MILITARY SPECIFICATION

MICROCIRCUITS, DIGITAL, LOW POWER SCHOTTKY, TTL, MONOSTABLE MULTIVIBRATORS, MONOLITHIC SILICON

This amendment forms a part of Military Specification MIL-M-38510/314B, dated 23 May 1984, and is approved for use by all Departments and Agencies of the Department of Defense.

TYPICAL OUTPUT PULSE WIDTH
vs
EXTERNAL TIMING CAPACITANCE

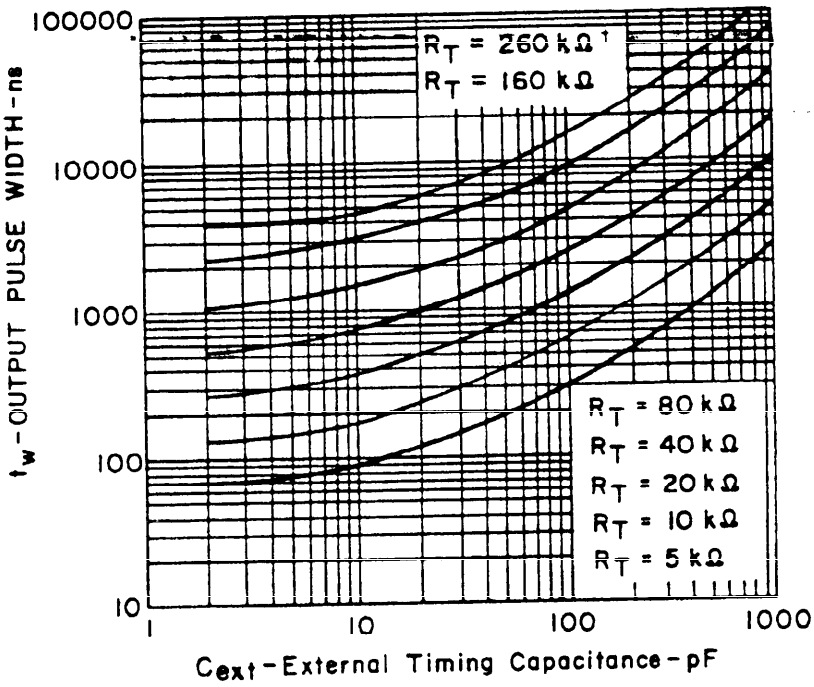
FIGURE 2, TYPICAL OUTPUT PULSE WIDTH vs EXTERNAL TIMING CAPACITANCE graph: Delete and substitute new graph as shown on page 3 of this amendment.
